SITE DEVELOPMENT PLAN
EL PASO COUNTY, COLORADO

FILE NO. EA-17-075

ARACO CONCRETE
SITE DEVELOPMENT PLAN
A PORTION OF THE SOUTHEAST QUARTER OF SECTION 24,
TOWNSHIP 15 SOUTH, RANGE 66 WEST OF THE 6TH P.M.,
EL PASO COUNTY, COLORADO

Site Development Plan_V3.pdf Markup Summary

1

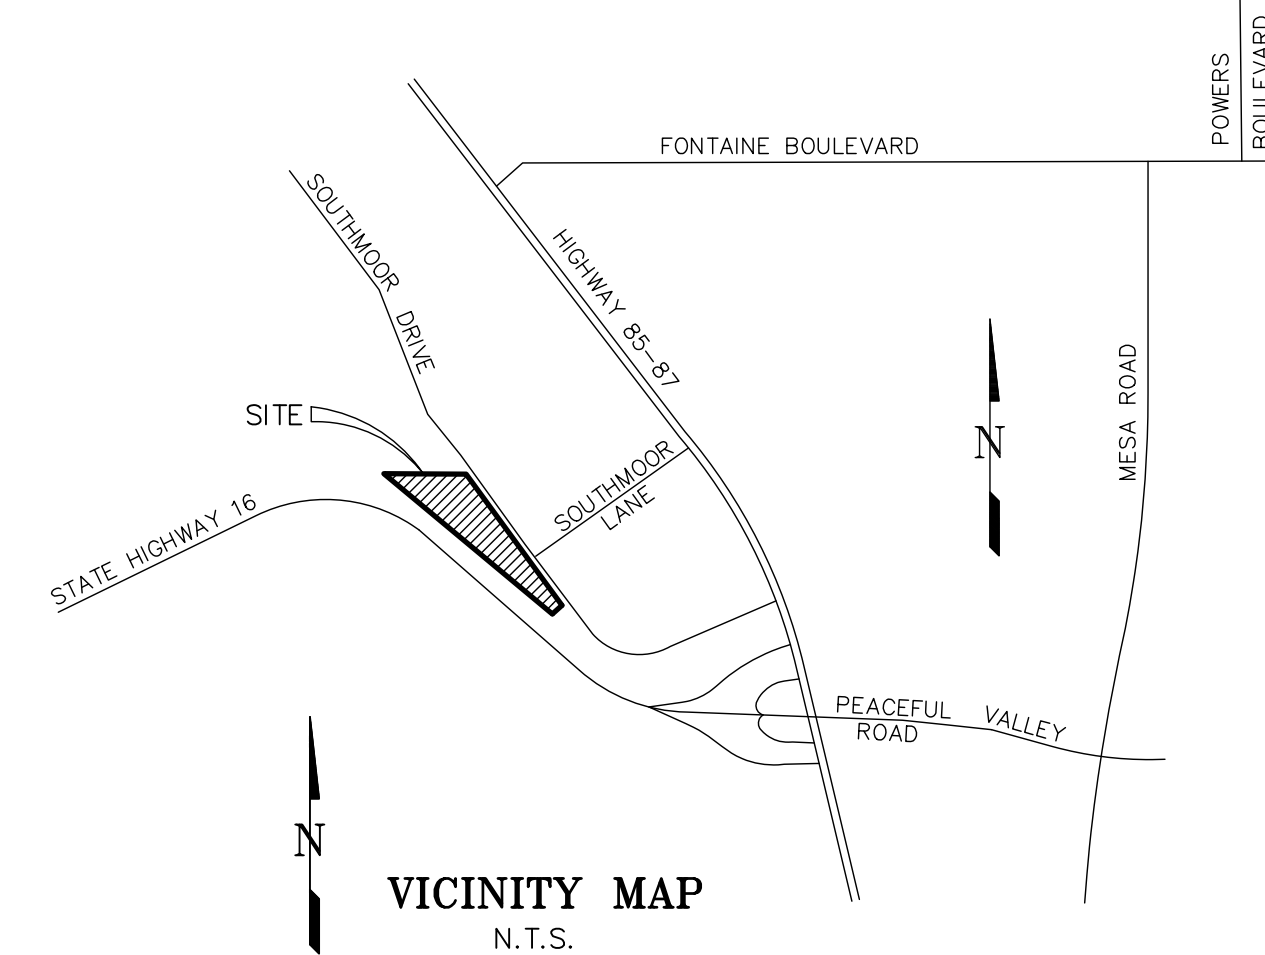
The dumpster enclosure appears to be enclosed / screened on only 3 sides and is also unclear as to the direction and whether there is a gate to the enclosure or if the front is open, etc. (though it is difficult to verify all this via the detail).

Please either clarify in your dumpster enclosure callouts, or revise the proposed dumpster enclosure, to comply with Ch.6.2.2(G)(1)(b) "Refuse Areas Screened"

the engineering manager is amenable to a 3rd access point although the driveway shall be limited to 40' wide per criteria. Currently the driveway shown is +111'. Provide the appropriate curb/gutter at this location such that the driveway is limited to max 40' wide. Additionally, a sign indicating that there shall be no backing into Southmoor drive shall be provided. Staff has discussed this information with your traffic engineer.
